RHODE ISLAND DEPARTMENT OF TRANSPORTATION

RHODE ISLAND CONTRACT NO.2013-CB-080

Kent Dam Spillway Bridge No. 84 & Scituate Ave 1R

NOTICE TO PROSPECTIVE BIDDERS

UTILITY ROOM
PLAN AND DETAILS

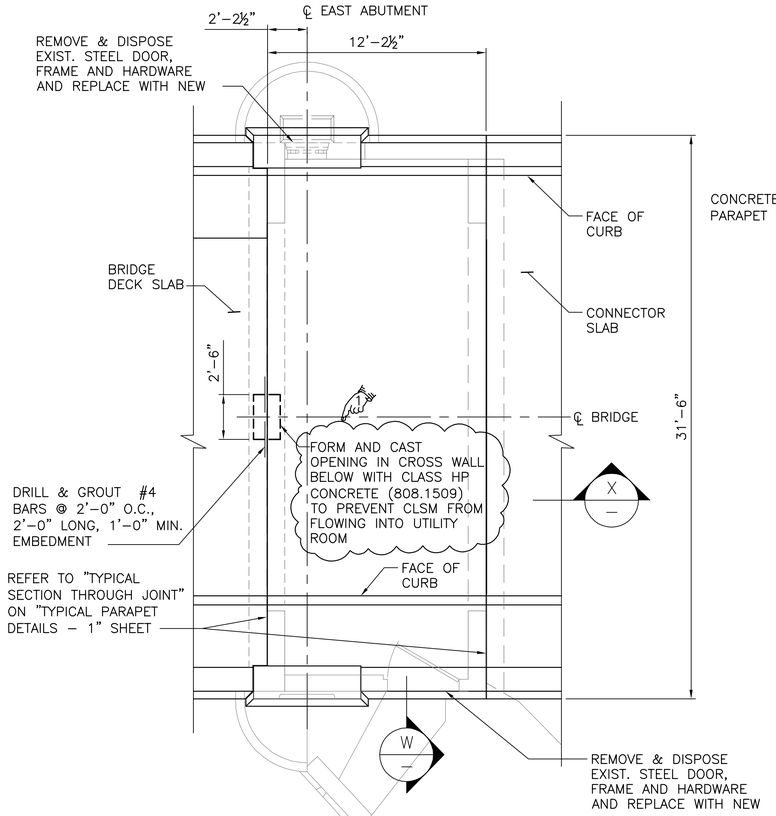
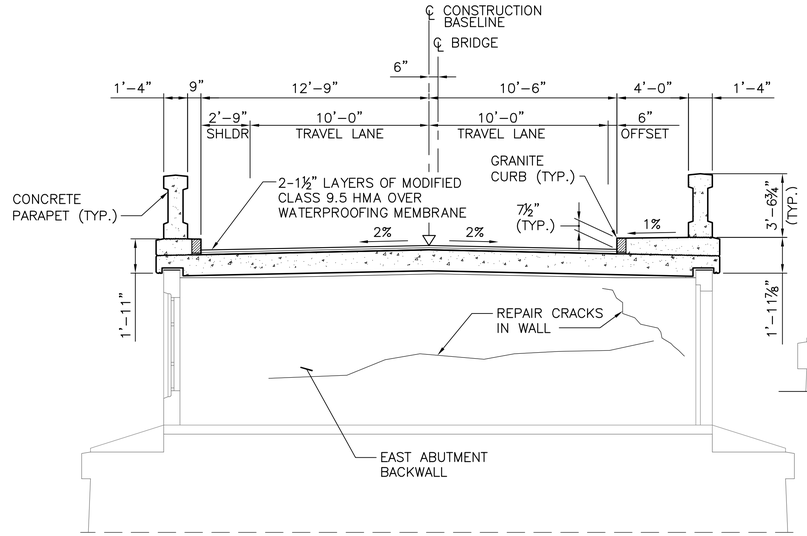
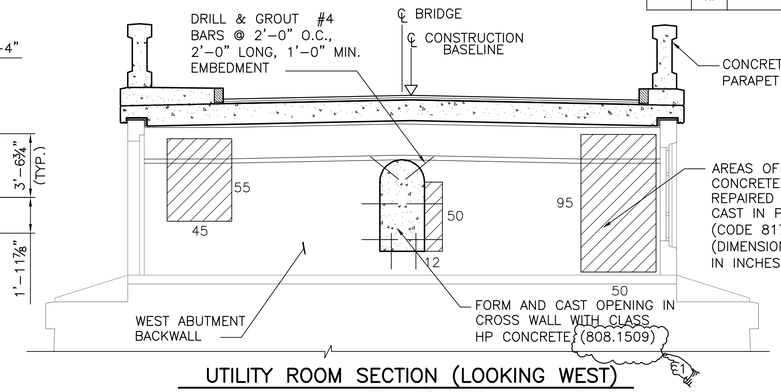
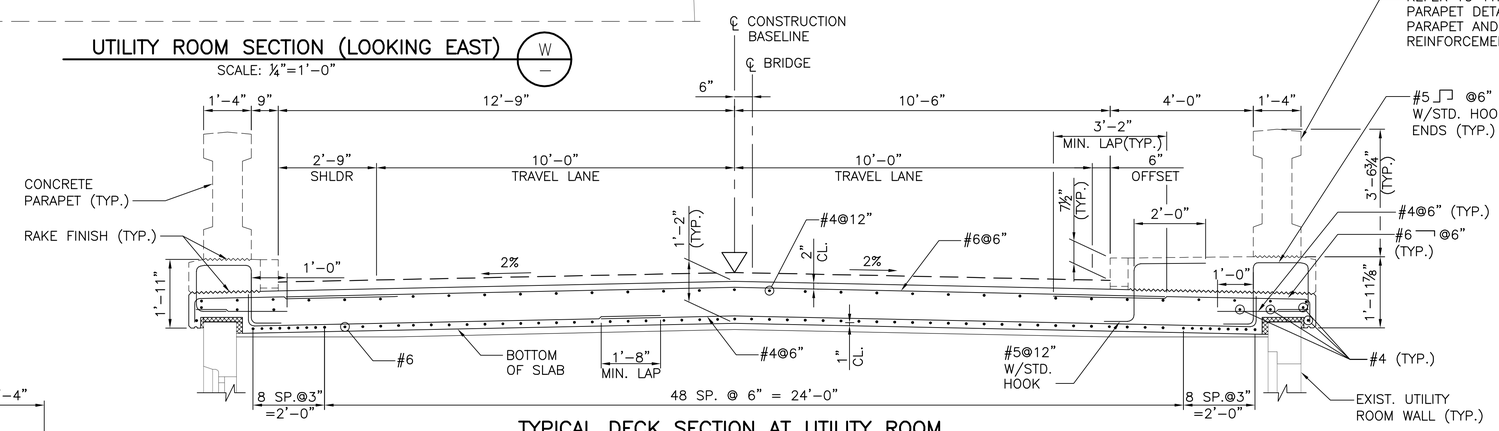
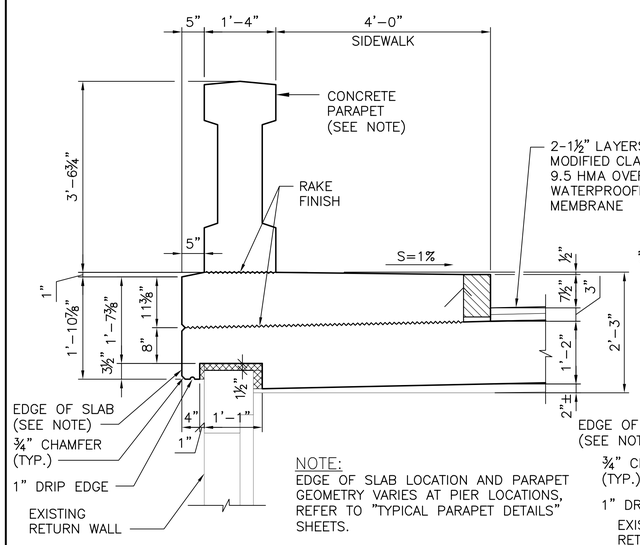
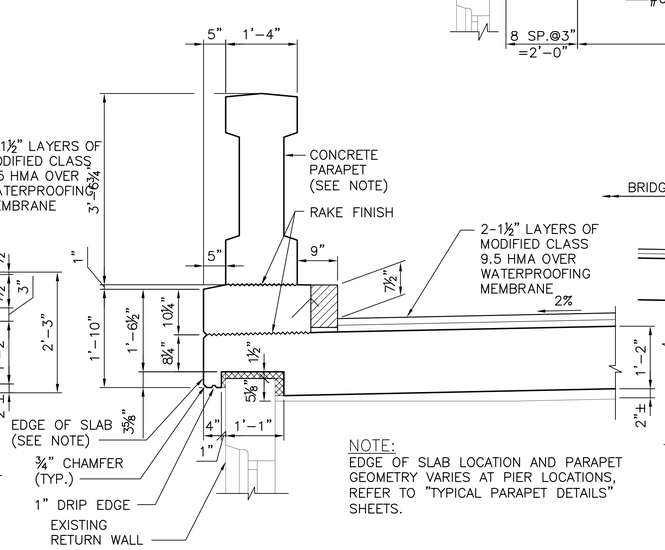
Remove Sheet No. 47 in its entirety and replace it with revised Sheet No. 47 (R-1) attached to this Addendum No. 1. The Item Code "808.1509" has been added to Cross Wall notes.

TYPICAL PVC DRAIN SYSTEM DETAIL

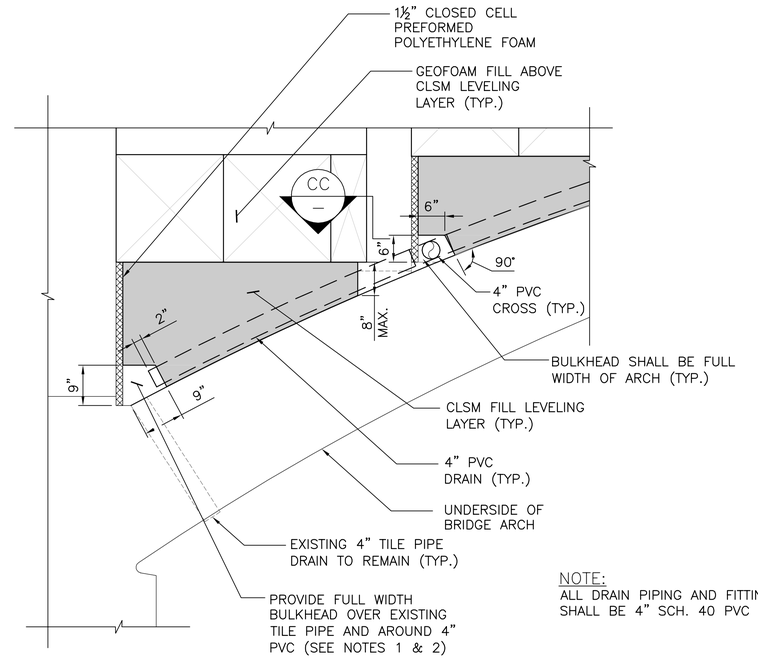
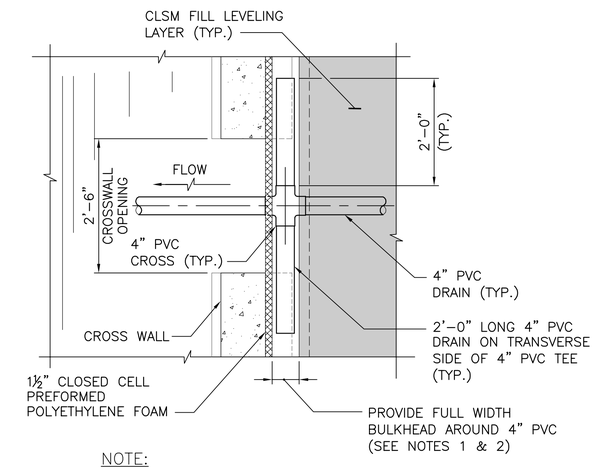
Remove Sheet No. 52 in its entirety and replace it with revised Sheet No. 52 (R-1) attached to this Addendum No. 1. PVC Drain Notes have been added.

NOTE:
ALL DRAIN PIPING AND FITTINGS SHALL BE 4" SCH. 40 PVC
